UNITED STATES PATENT AND TRADEMARK OFFICE

Office Action Summary	Application No. 10/696,932	Applicant(s) MCGUCKIN ET AL.	
	Examiner Richard Shaffer	Art Unit 3733

DETAILED ACTION

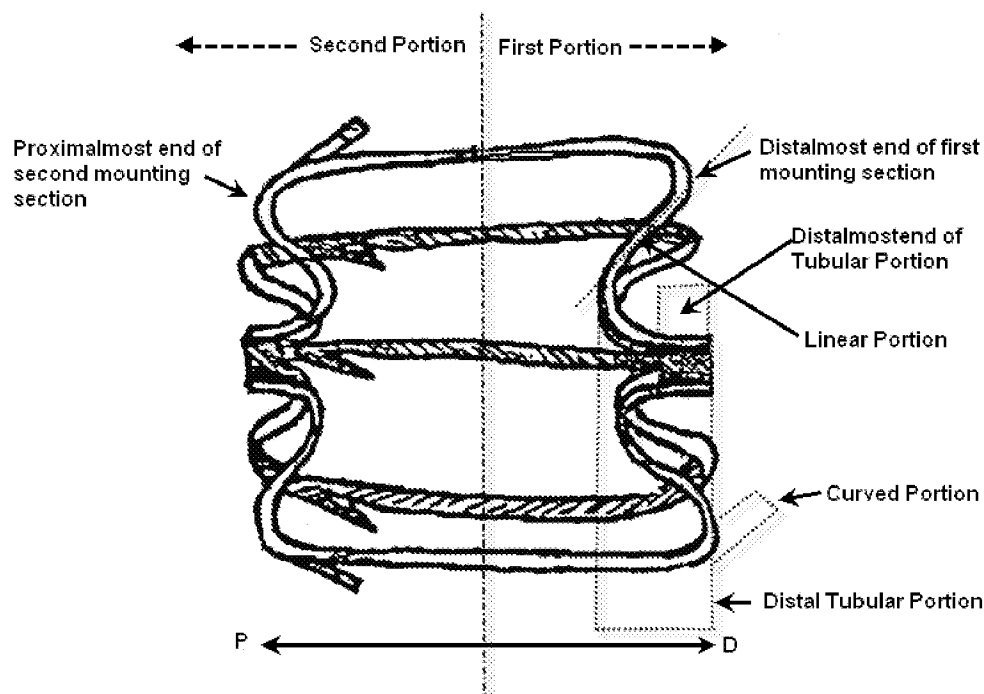
Bosma et al disclose all of the claimed limitations except for the specific structure and location of the filtering section with regard to the mounting section. van der Burg et al teach (**Figure 35; Column 18, Lines 34-55**) that an expandable device for placement against a bodily tubular structure with an S-shape end portion provides an elongated mounting section which improves contact area. It would have been obvious to one having ordinary skill in the art at the time of invention to design the filter of Bosma et al according to the structure taught in van der Burg et al in order to improve fixation within the blood vessel. In regard to applicant's extensive claim language defining the relationship between the filter section and mounting section, see the Figure below depicting how the structure of van der Burg et al meets the claimed limitations.

Applicant's arguments filed March 3rd, 2008 have been fully considered but they are not persuasive. In particular, a new interpretation of the device of van der Burg et al has been conducted due to the new independent claims. Specifically, it is shown how the structure discloses a linear portion longer than a curved portion as well as the distalmost end of the distal tubular section is proximal to the distalmost end of the distal mounting section.
